STATEMENT OF ENVIRONMENTAL EFFECTS – S4.55
PROPOSED DWELLING
198 HENRY LAWSON DRIVE
GEORGES HALL 2198

Issued: 17/10/2024

This Statement of Environmental Effects has been prepared to accompany a S4.55(2) modification to the approved Development Application (DA) **DA-667/2017/A** to the City of Canterbury-Bankstown Council (Bankstown) seeking consent for the demolition of existing structures and the construction of a two-storey dwelling house at **198 Henry Lawson Drive, George Hall**.

Figure 2. Ground Floor Plan for DA-667/2017/A prepared by PTW Architects.

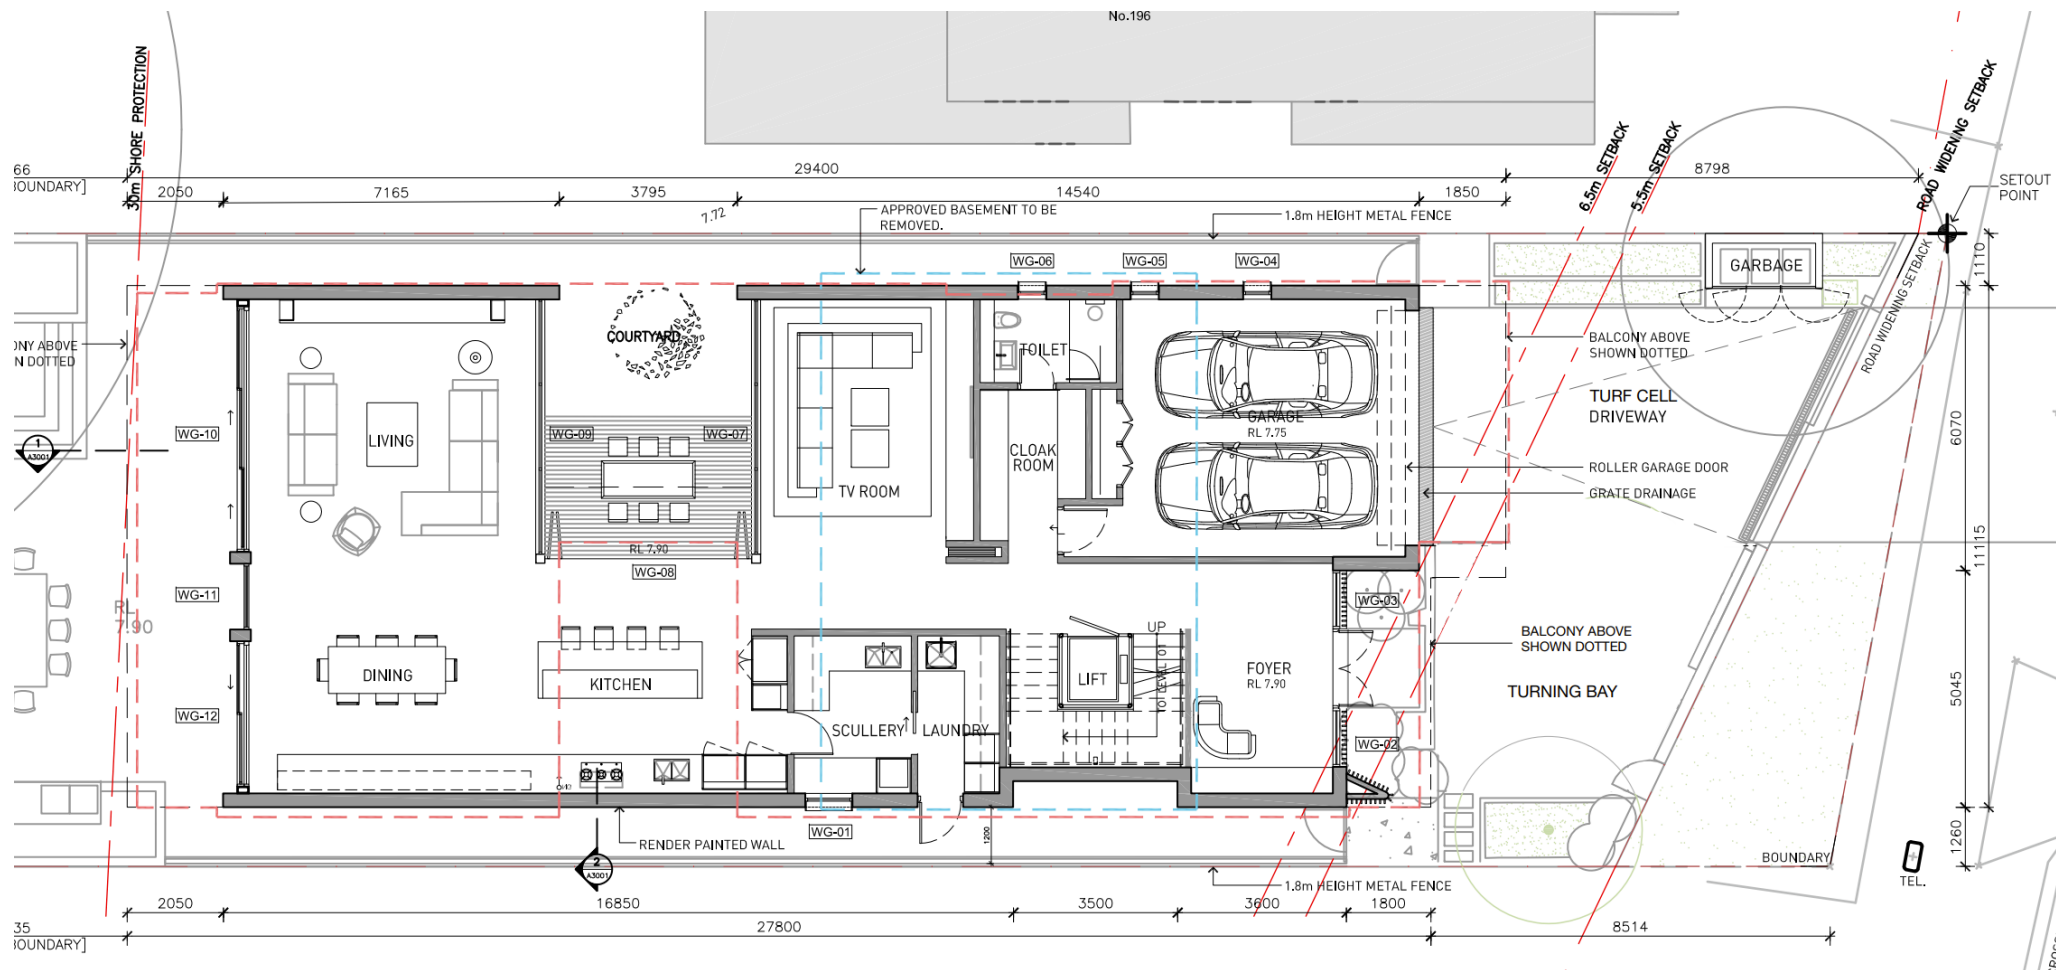
1. Stair/lift well moved to previous courtyard location. Associated glazing removed from proposal. Glazed block wall proposed.
2. Courtyard moved to previous stair/lift well location. Associated window and storage proposed.
3. Side boundary fences amended. Entry fence, gates and planters amended.

4. Northwestern glazed sliding/stacking doors amended.
5. Relocation of kitchen island to provide dining space in previous kitchen island location.
6. Minor redesign of ground floor bathroom.
7. Entry door increased in width. Sidelights reduced in width.

Refer to Figures 2. and 3. for a comparison of the Ground Floor Plan submitted for **DA-667/2017/A** and the Ground Floor Plan for this S4.55(2) submission, with the above modifications highlighted in yellow and numbered.

Figure 5. First Floor Plan for S4.55(2) submission prepared by Alvaro Architects.

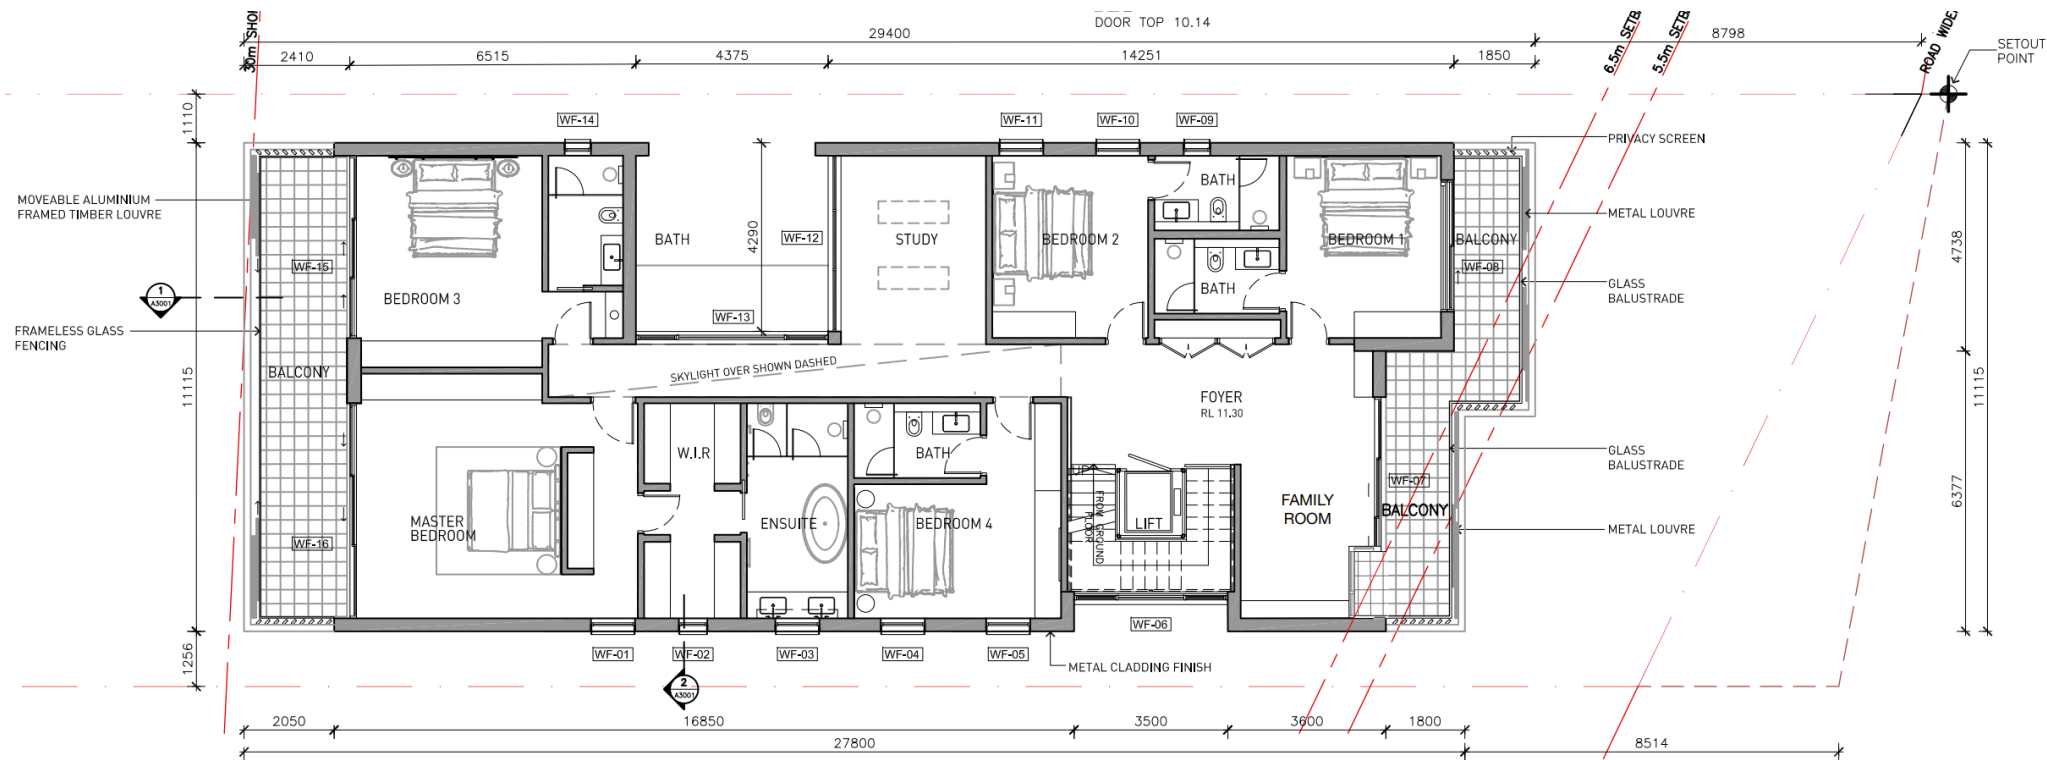
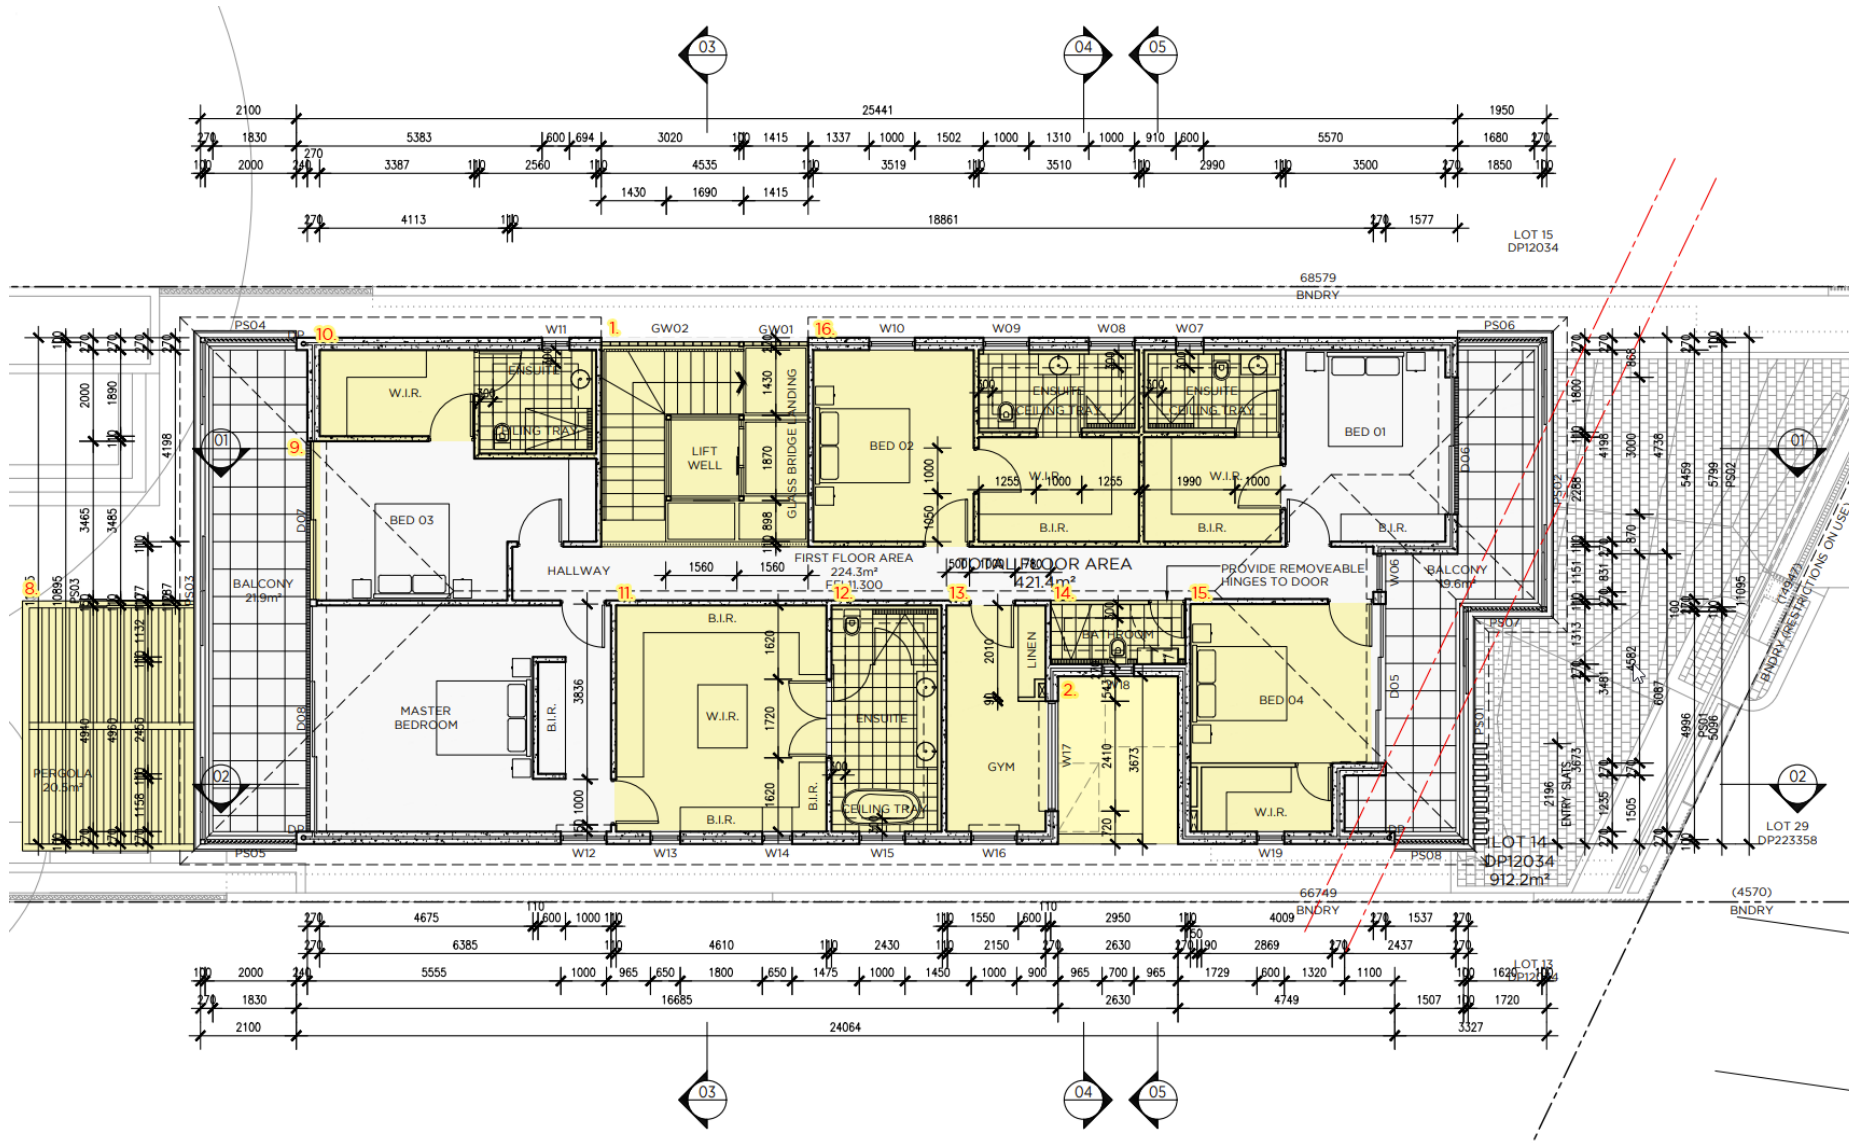
8. Pergola proposed over principle private open space.
9. Bed 03 sliding door relocated due to redesign of interior space.
10. Bed 03 redesigned with walk in robe and redesigned ensuite.
11. Master walk in robe increased in size.
12. Master ensuite moved as a result on walk in robe increase with minor redesign.
13. Gym proposed in previous Bed 04 location.
14. Previous Bed 04 ensuite relocated and changed to communal bathroom.
15. Bed 04 repositioned in place of previous Family Room.
16. Study no longer proposed. Bed 02 relocated to study location. Walk in robes provided for Bed 01 & 02. Respective ensuites redesigned.

Refer to Figures 4. and 5. for a comparison of the First Floor Plan submitted for **DA-667/2017/A** and the First Floor Plan for this S4.55(2) submission, with the above modifications highlighted in yellow and numbered.

Figure 7. Roof Plan for S4.55(2) submission prepared by Alvaro Architects.

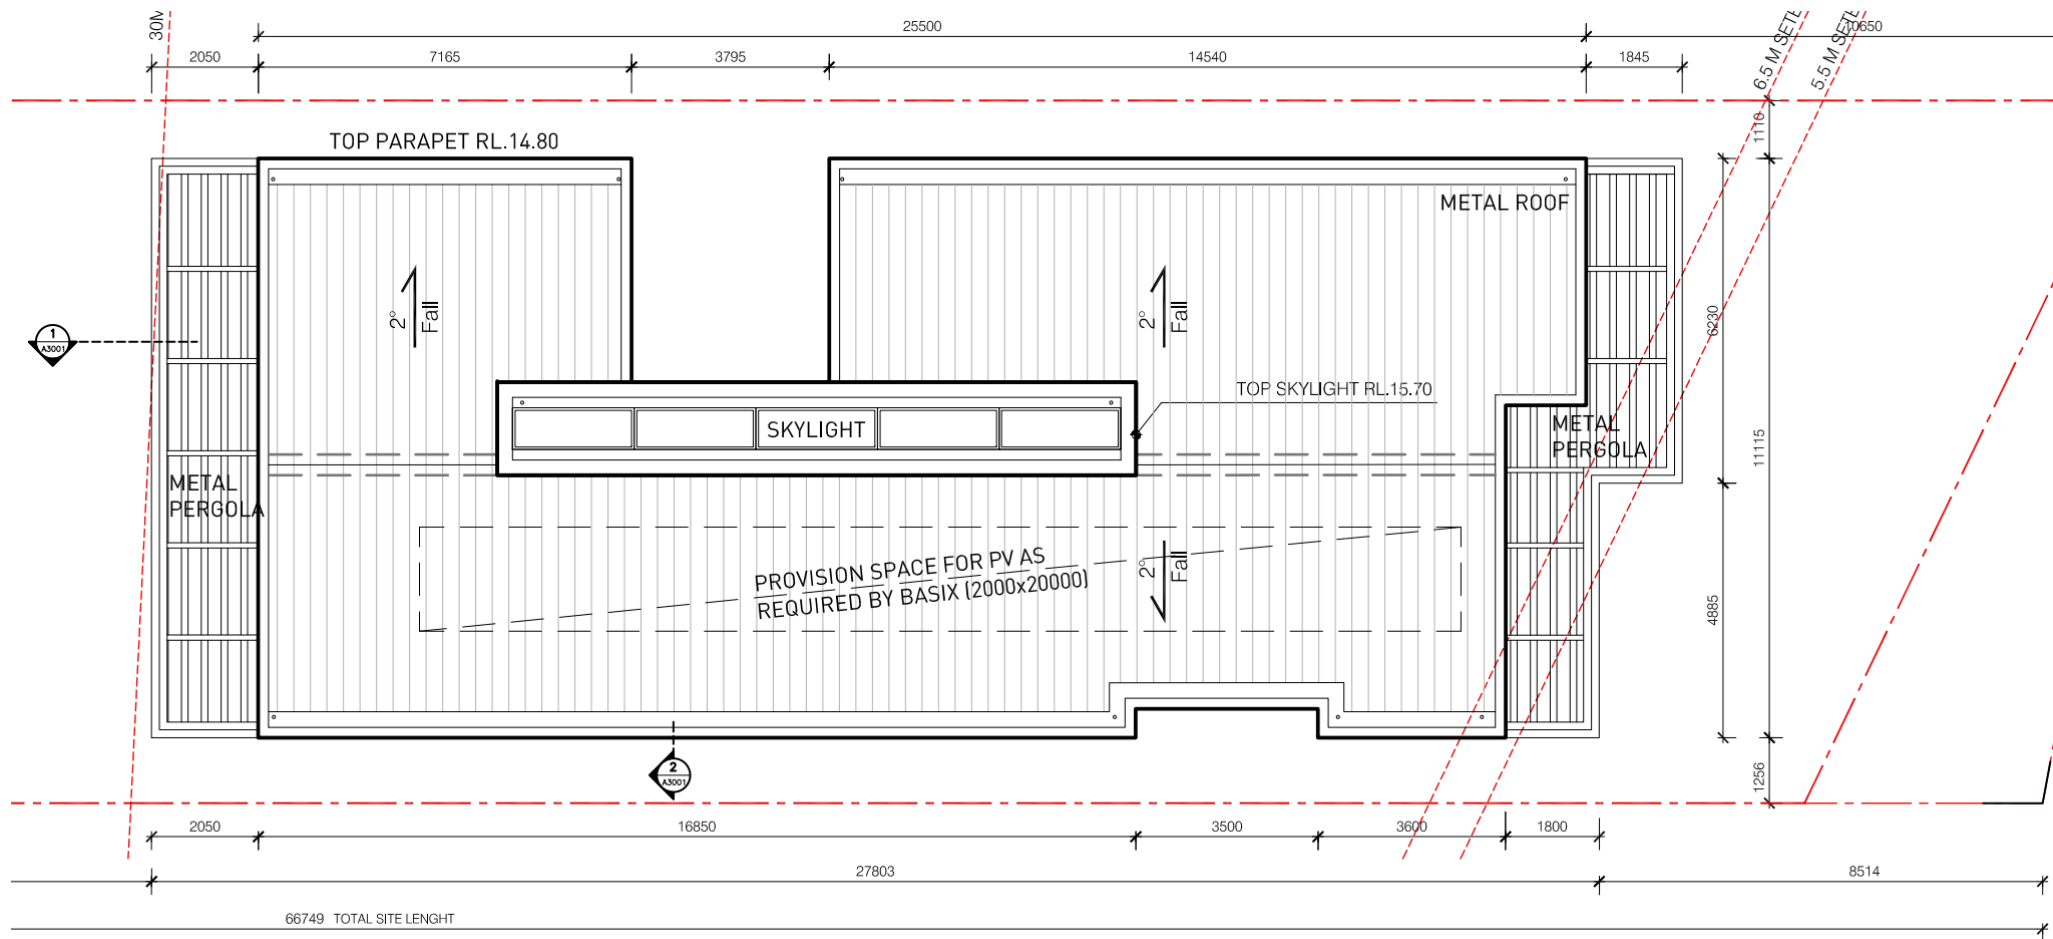
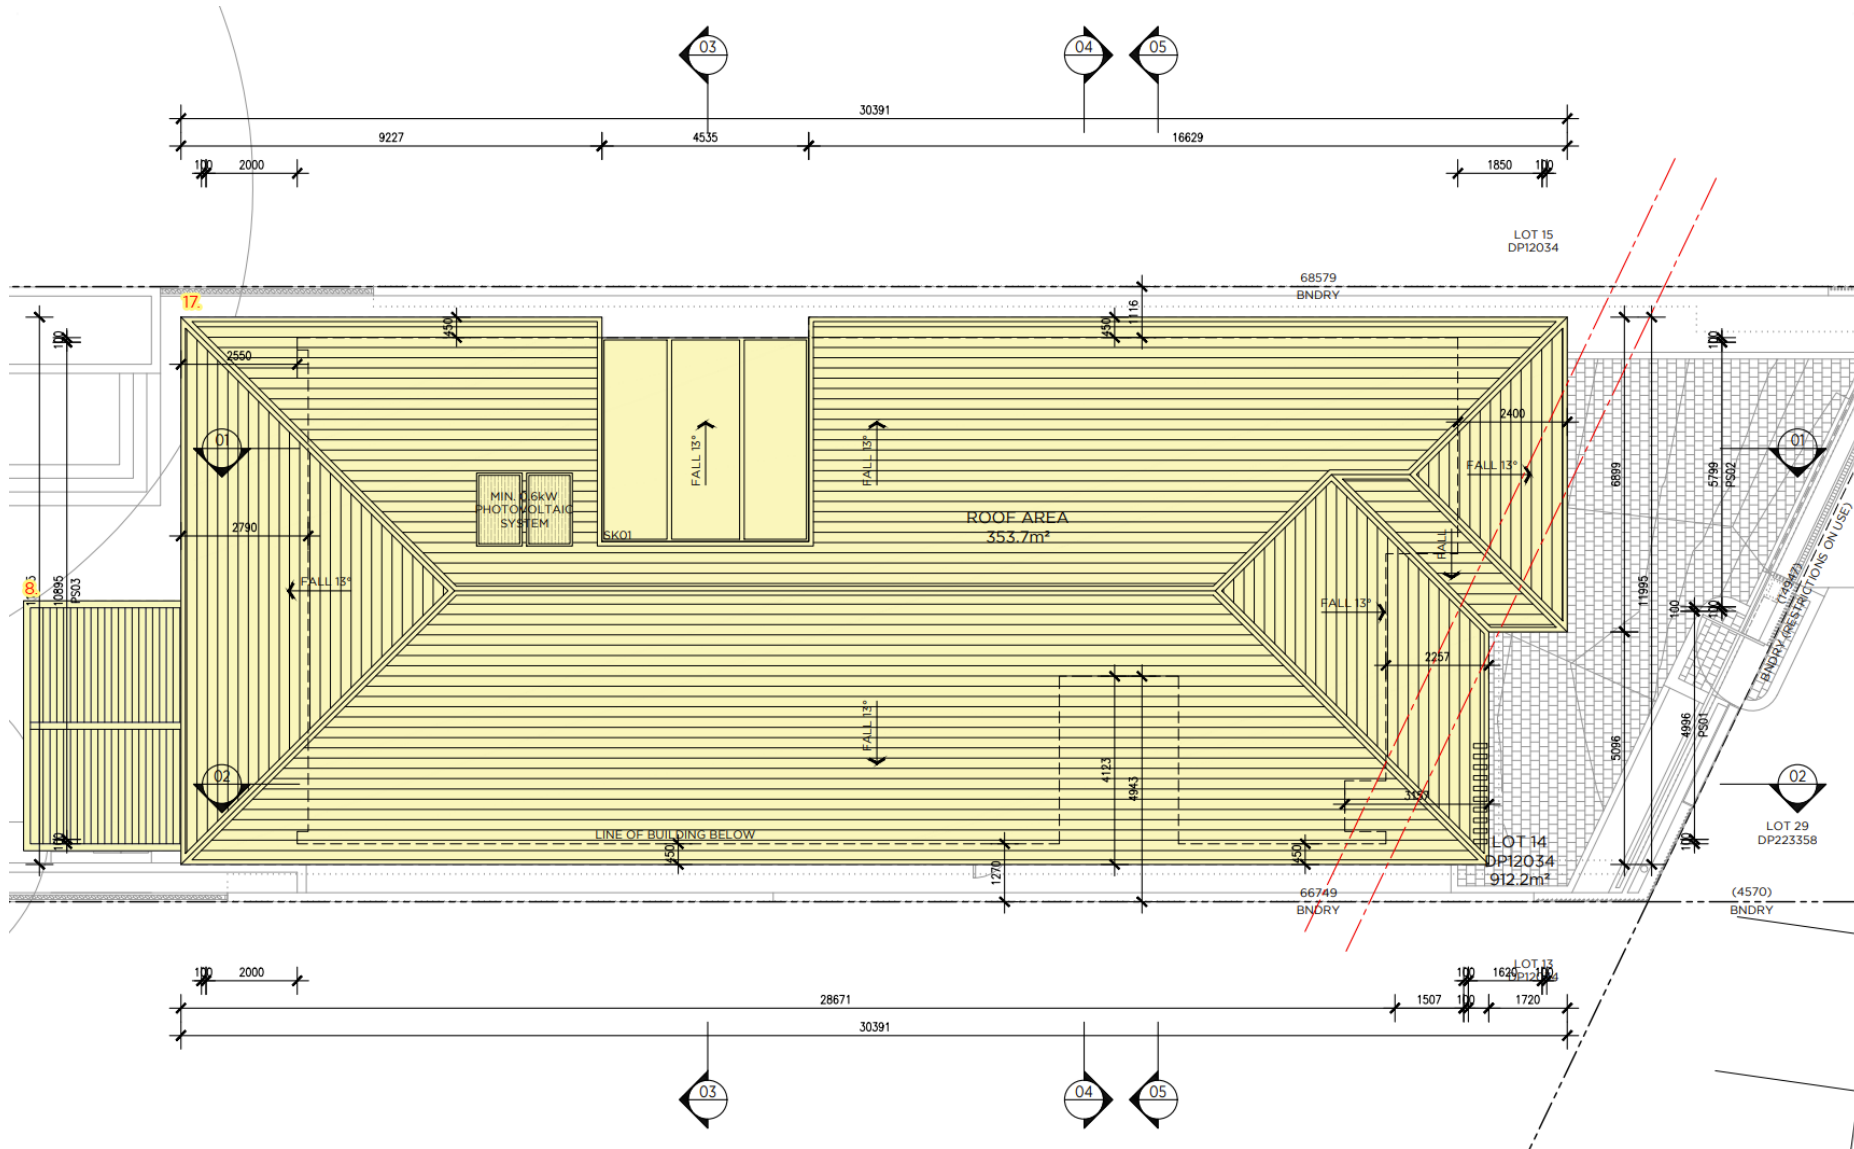
17. Roof amended from flat roof with parapets to standard hip and valley roof. Previous parapets no longer proposed.

Refer to Figures 6. and 7. for a comparison of the Roof Plan submitted for **DA-667/2017/A** and the Ground Floor Plan for this S4.55(2) submission, with the above modifications highlighted in yellow and numbered.
